This addendum forms a part of the Contract Documents and modifies the original Documents dated **September 26, 2022**, as noted below. Acknowledge receipt of this addendum in the space provided on the Official Bid Form. Failure to do so may subject the Bidder to disqualification.

**END OF ADDENDUM 2**

A2.01

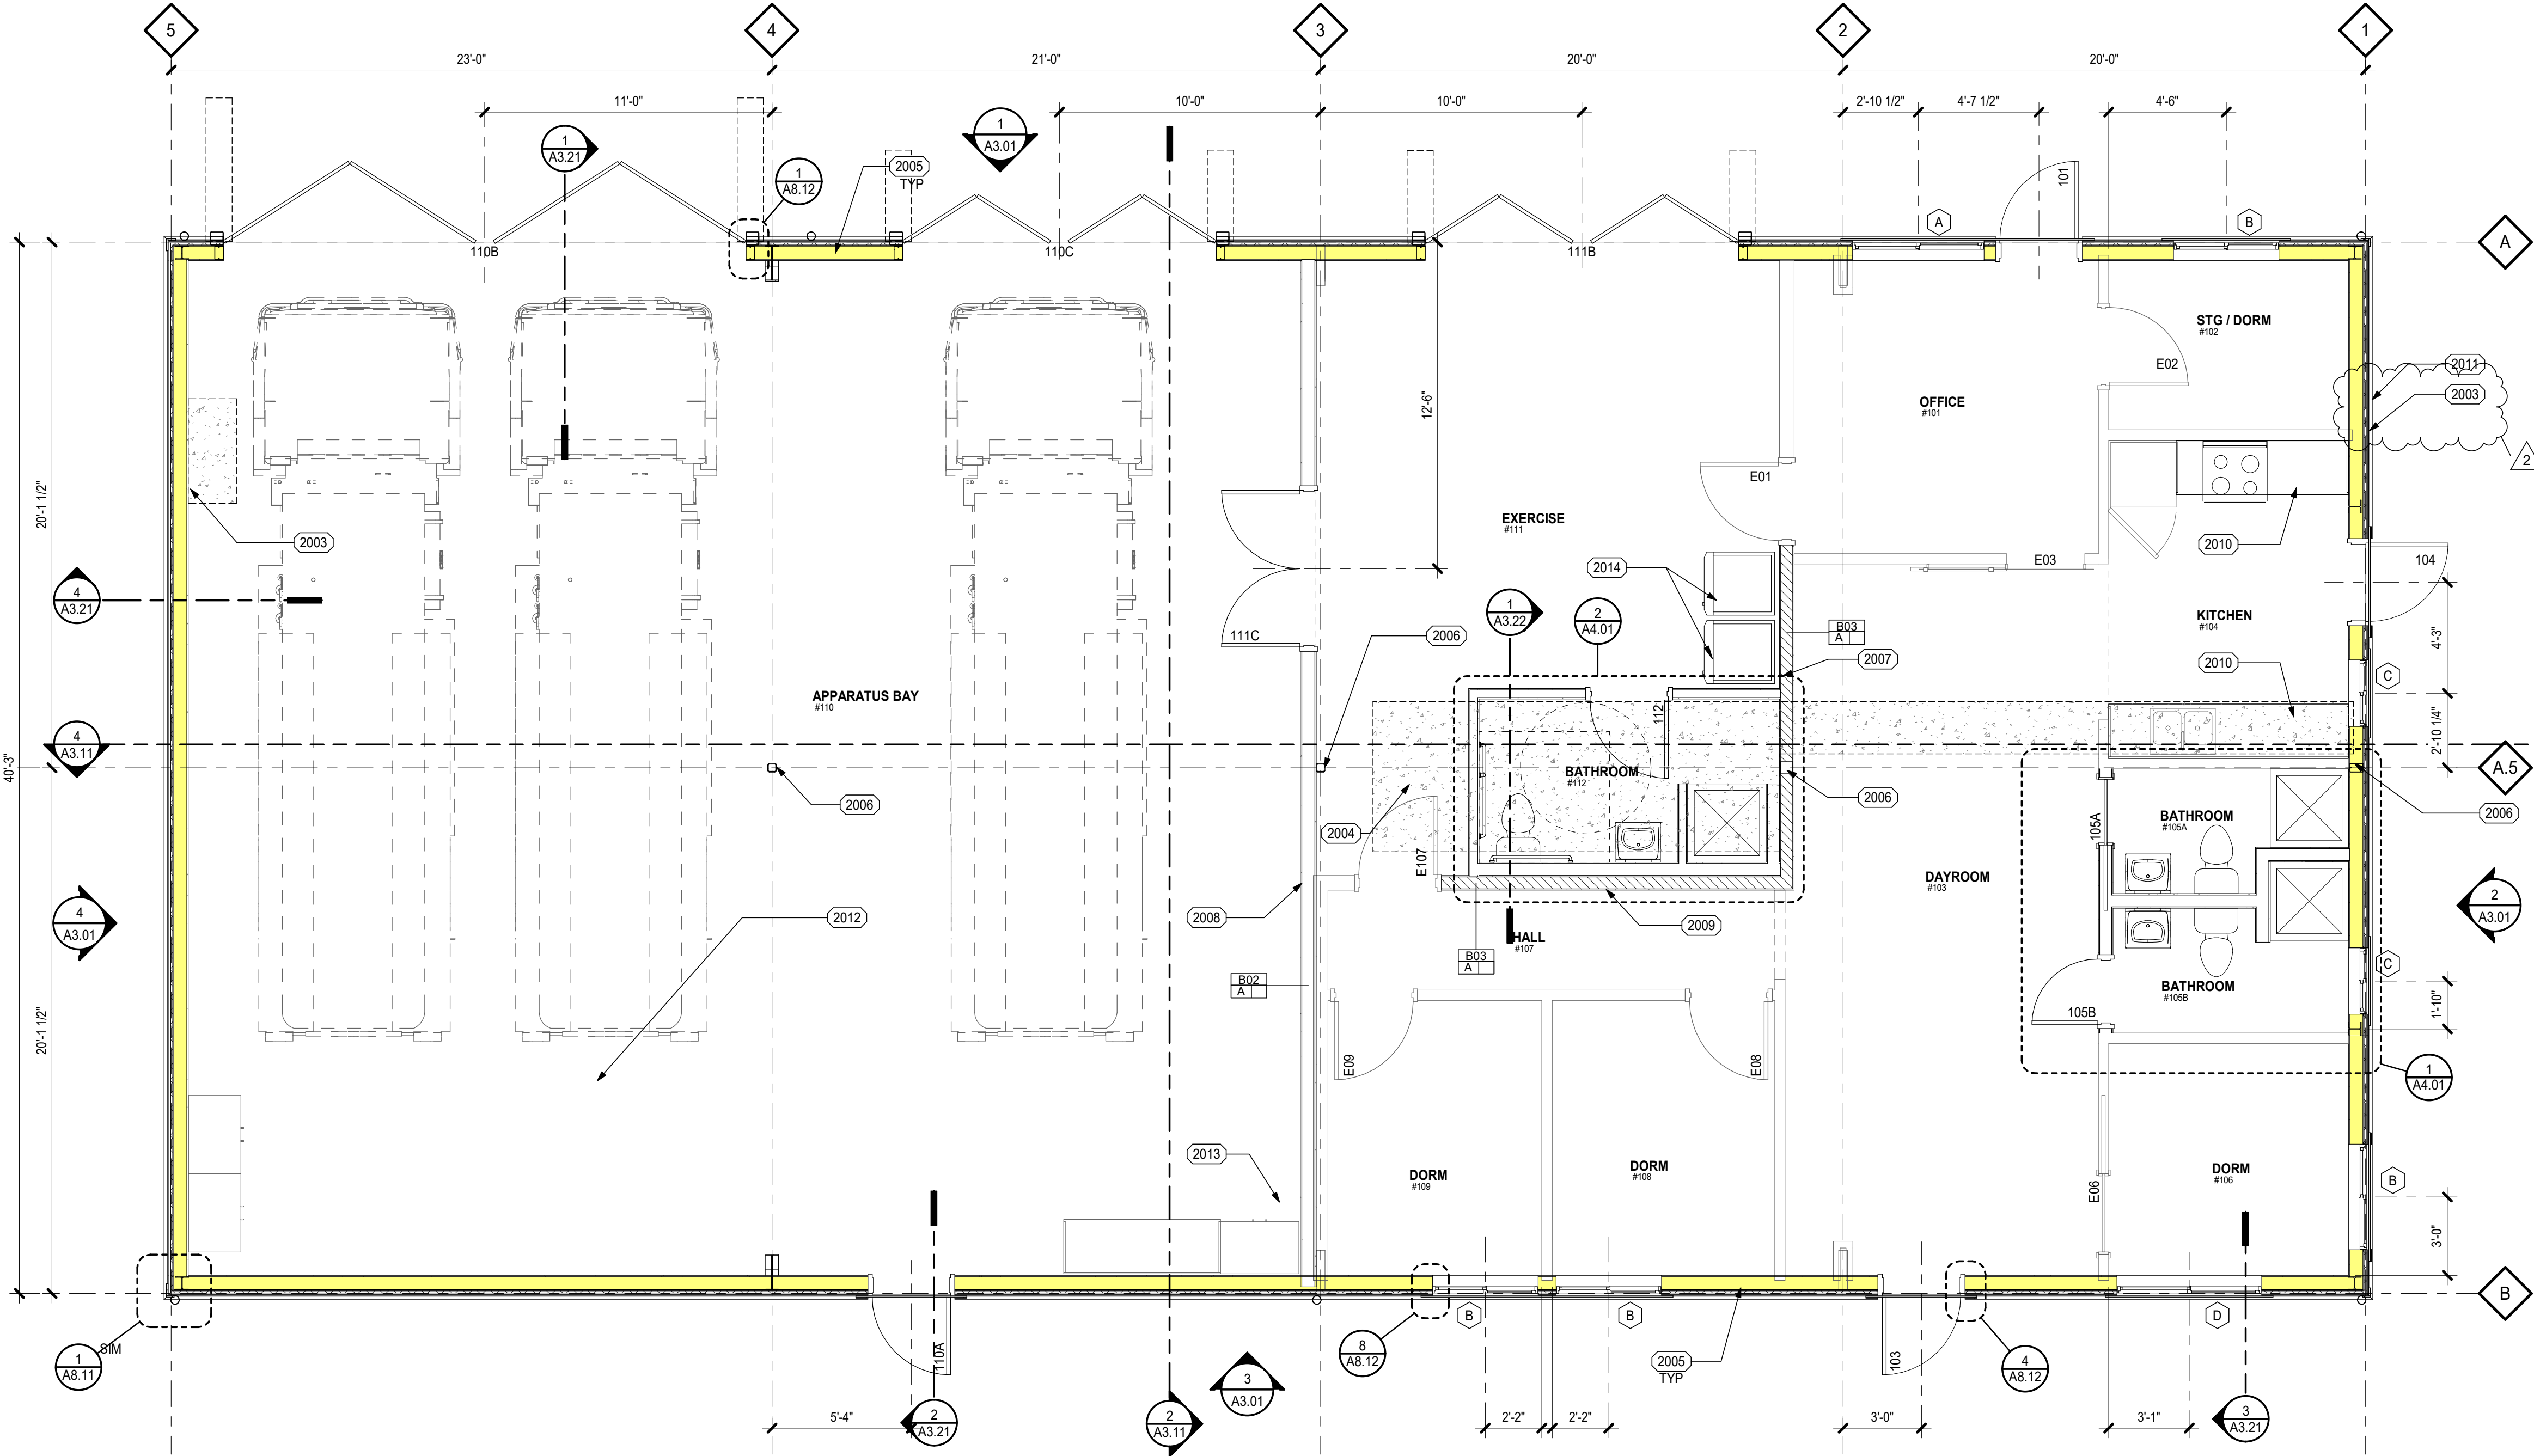
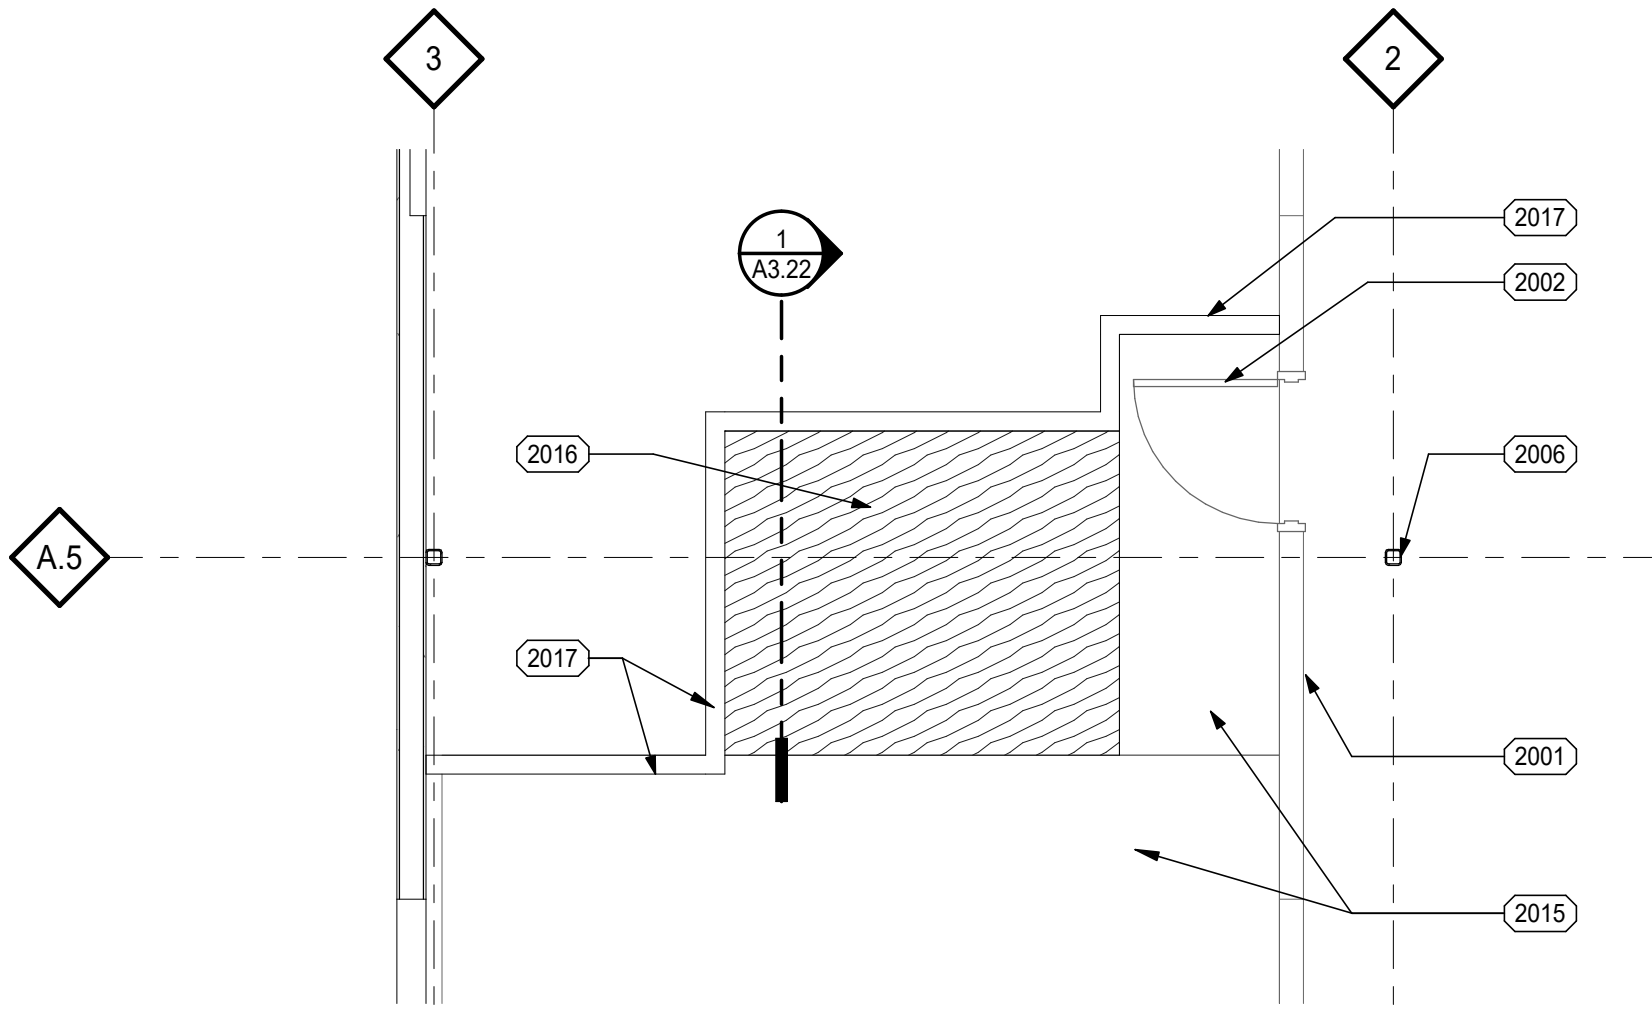
**Answer:** See attached revised plan sheets A1-01 and A2-01 for updated specifications for the generator conduit installation. This is conduit installation only.

A2-01

1. See clouded section

MARK	DESCRIPTION
2001	EXISTING WALL TO REMAIN
2002	EXISTING DOOR TO REMAIN
2003	PROVIDE 4" DIA CONDUIT FOR FUTURE GENERATOR CONNECTION. PROVIDE PULL ROPE AND CAP AT BOTH ENDS. STUB TO EXTENTS INDICATED ON SITE PLAN.
2004	PROVIDE UNDERSLAB WASTE PIPING FOR RESTROOM AND LAUNDRY. SIZE FOR ONE ADDITIONAL TOILET, SHOWER, AND LAVATORY ABOVE WHAT IS SHOWN.
2005	NEW EXTERIOR WALL ASSEMBLY. SEE DETAIL 1/A0.11
2006	NEW COLUMN. SEE STRUCTURAL
2007	NEW BEARING WALL. SEE STRUCTURAL
2008	NEW SHEAR WALL. SEE STRUCTURAL
2009	REPLACE ANY FLOORING MATERIALS REMOVED OR DAMAGED DURING CONSTRUCTION WITH SAME TYPE.
2010	REPLACE EXISTING COUNTERTOPS, CABINETS, AND APPLIANCES REMOVED DURING CONSTRUCTION. CONNECT ALL PLUMBING AND ELECTRICAL HOOK-UPS.
2011	REPLACE ELECTRICAL SERVICE GEAR. MOUNT ON FIRE-TREATED PLYWOOD BACKING
2012	RE-INSTALL ANY LIGHTS OR HEATERS REMOVED DURING CONSTRUCTION. REPLACE ANY THAT WERE NOT SALVAGED.
